Presently, the Comanche Peak Steam Electric Station (CPSES) Technical Specifications, have Administrative Controls which are written to apply only to the operation of CPSES Unit 1. The purpose of these changes is to revise those Administrative Controls necessary for the CPSES Technical Specifications to be applicable to both CPSES Unit 1 and Unit 2. These changes are patterned after the standard technical specifications and reflect CPSES specific minimum staffing requirements.

II. DESCRIPTION OF TECHNICAL SPECIFICATION CHANGE REQUEST

II. DESCRIPTION OF TECHNICAL SPECIFICATION CHANGE REQUEST

CPSSES SERVICE WATER SYSTEMS

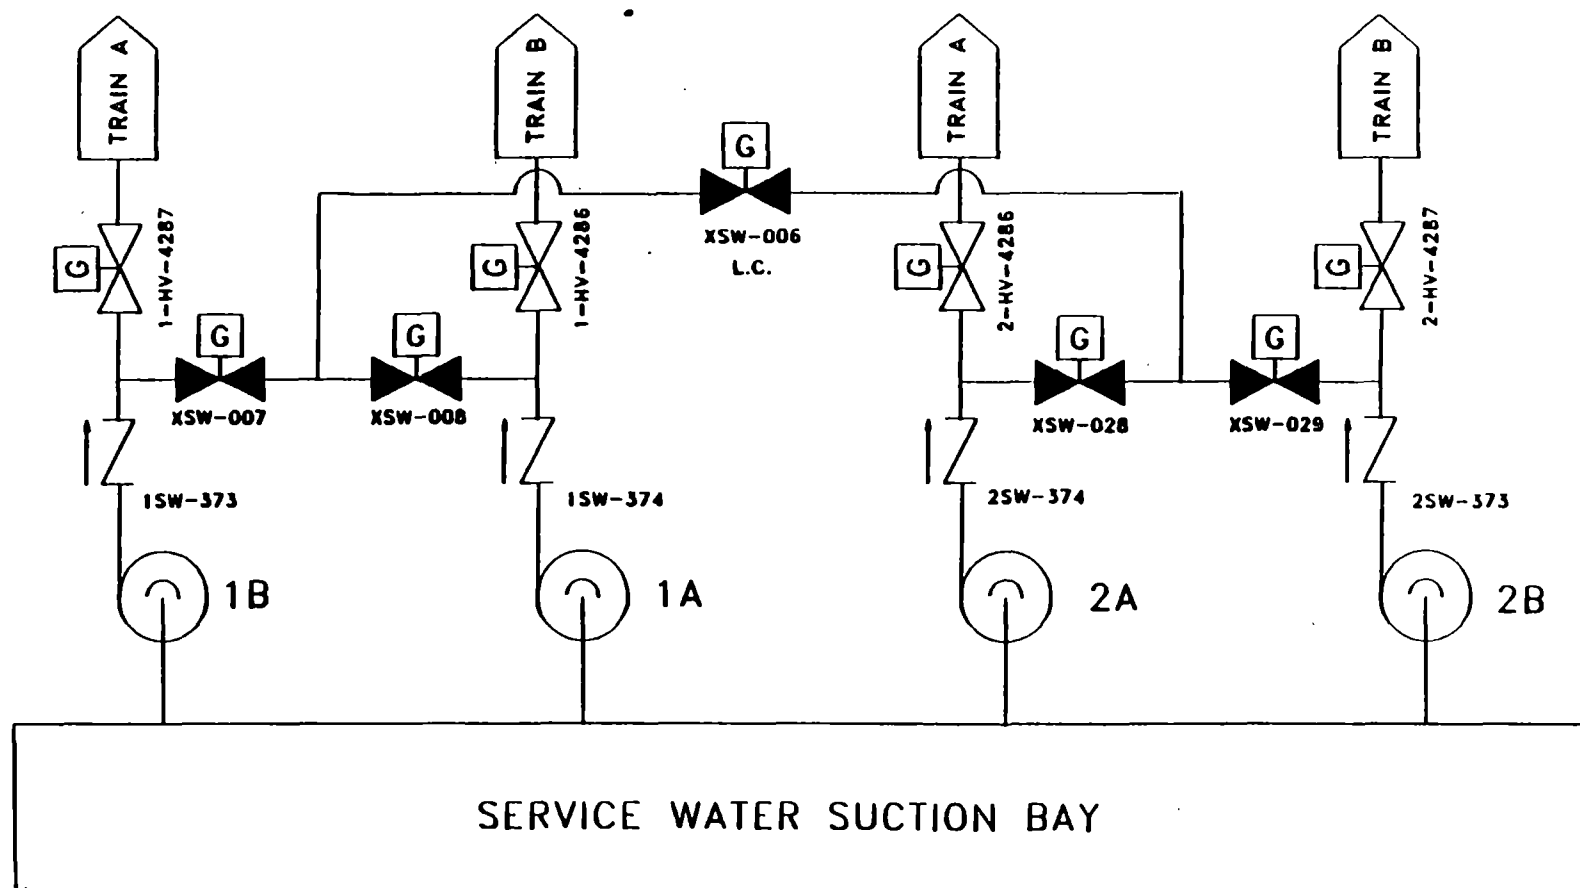
The normal SSWS configuration is shown on the attached sketch (Figure 1). Train isolation by two normally closed valves in series or one locked closed valve is provided to satisfy GDC-44. Unit isolation by one locked closed valve is provided to satisfy GDC-5. A service water pump for an operating unit is inoperable when its associated cross-connect is open. See Table 2 for acceptable combinations for the cross-connects.

The proposed change to TS 3/4.7.4 adds the requirement for a cross-connect between the station service water systems to be OPERABLE when either or both units are in MODE 1, 2, 3, or 4. It also adds the requirement for a minimum of one station service water pump to be OPERABLE to support the other unit in the event of a loss of essential service water event in a Unit in MODE 1, 2, 3, or 4.

FIGURE 2.1-1a

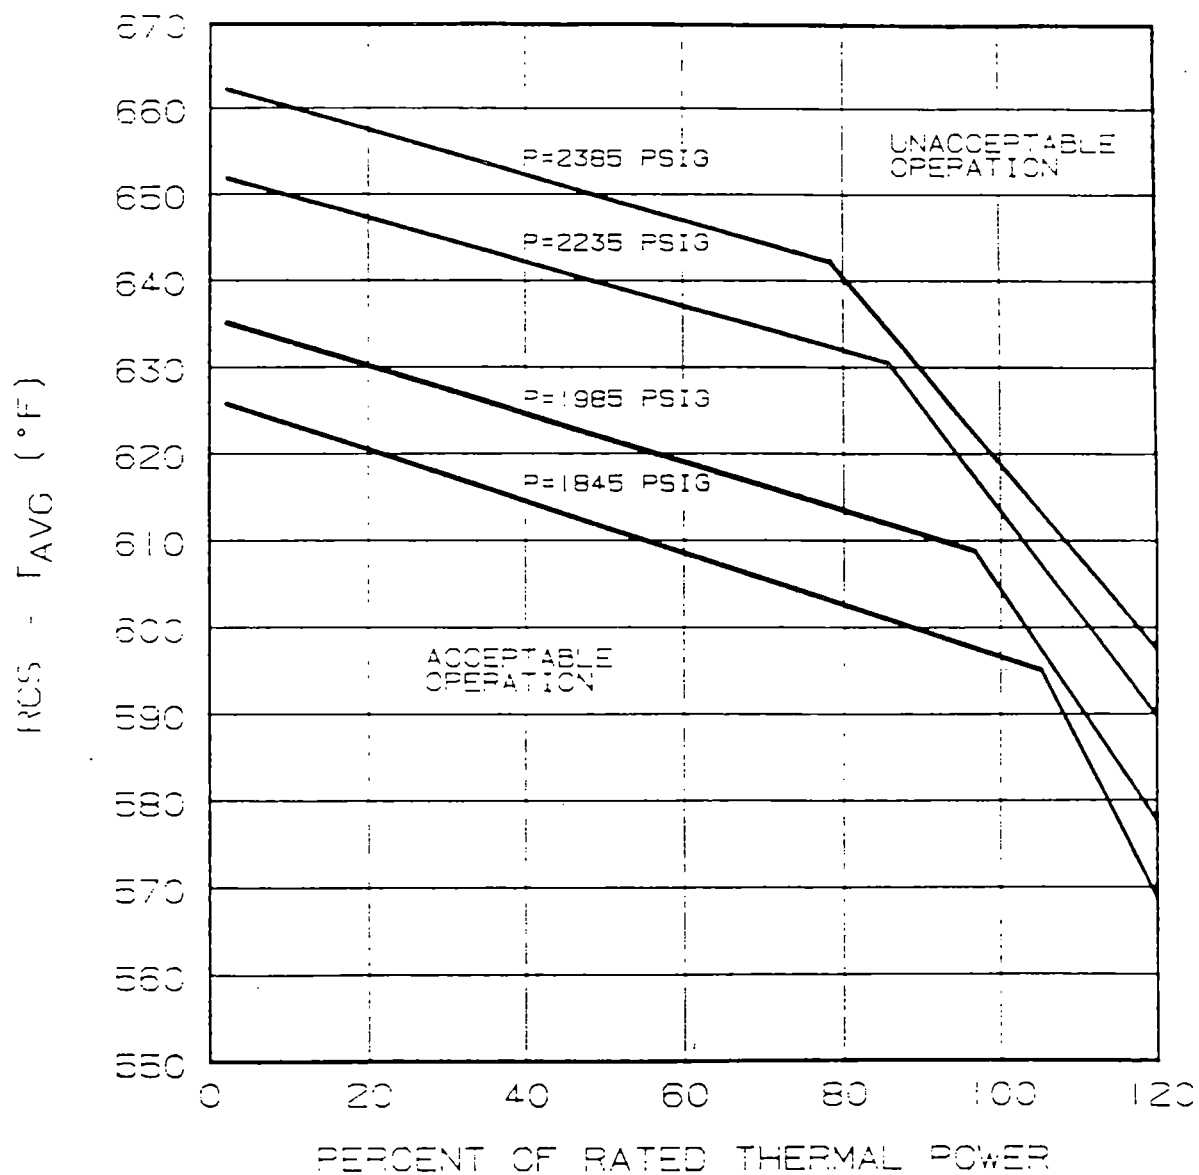
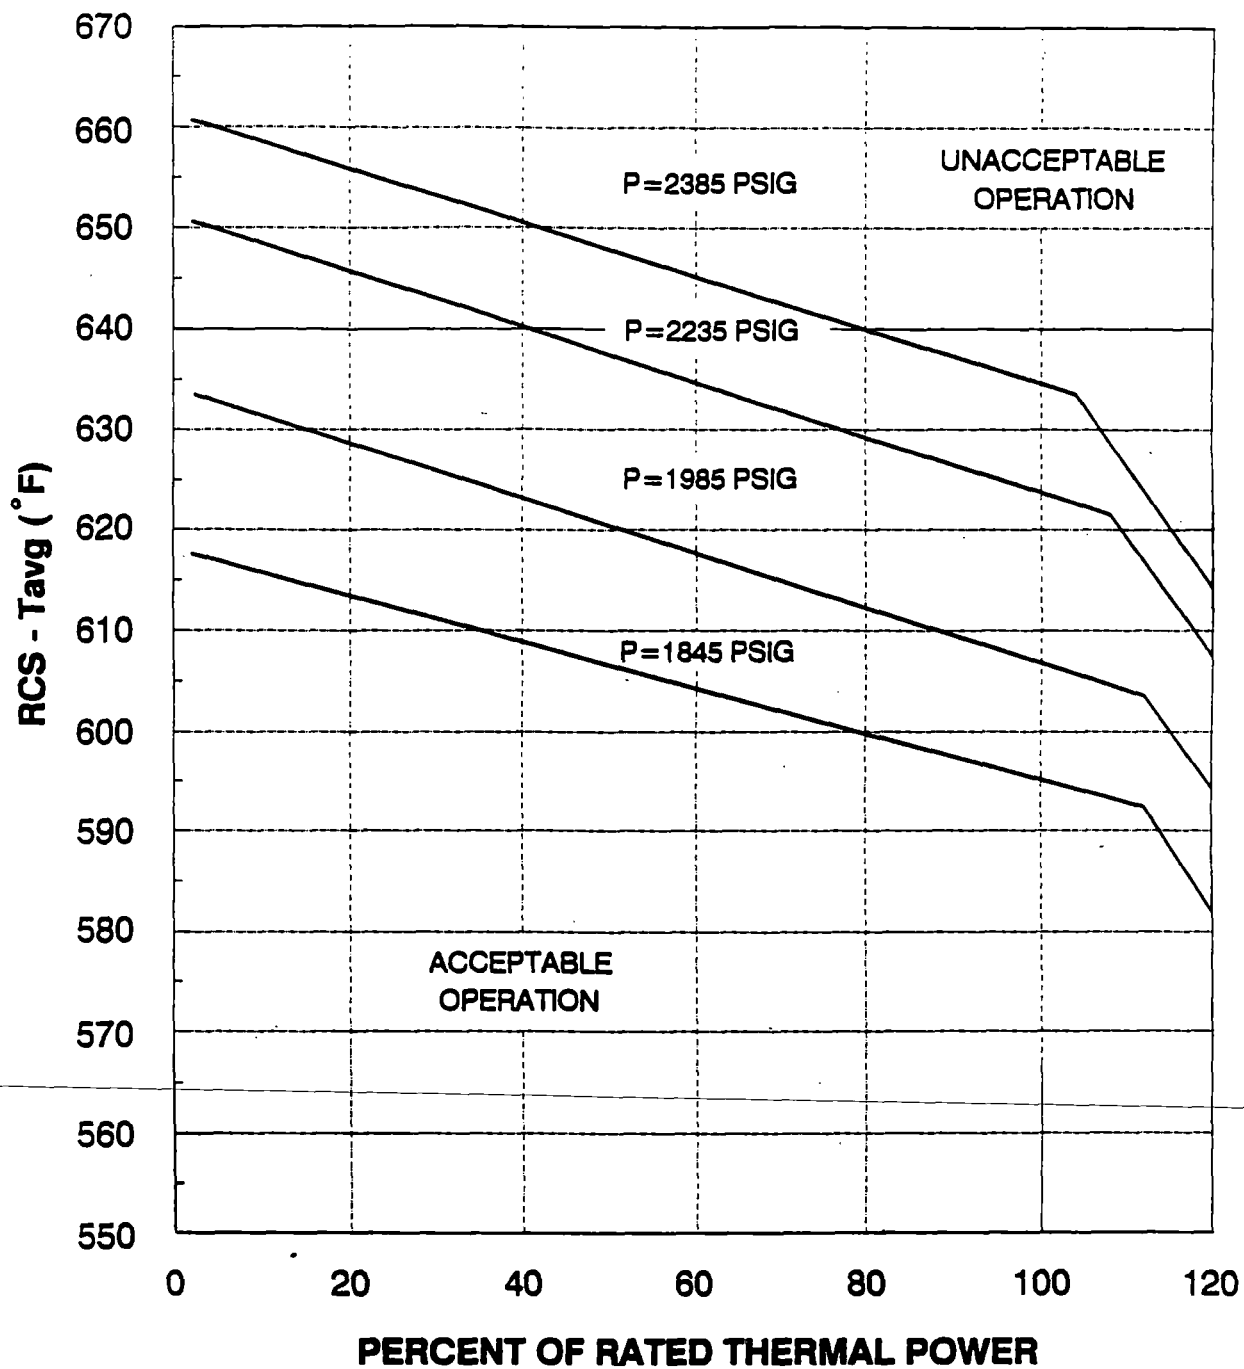
The change to page iii adds a Unit 2 reactor core safety limit figure and makes necessary changes to the title of the Unit 1 figure. The actual changes are to change "Figure 2.1-1 Reactor Core Safety Limit" to "Figure 2.1-1a Unit 1 Reactor Core Safety Limit" and to add "Figure 2.1-1b Unit 2 Reactor Core Safety Limit." The change is consistent with those being proposed on pages 2-2 and 2-2a.

Page 2-2a is added to include "Figure 2.1-1b Unit 2 Reactor Core Safety Limit" as described in the previous paragraph.
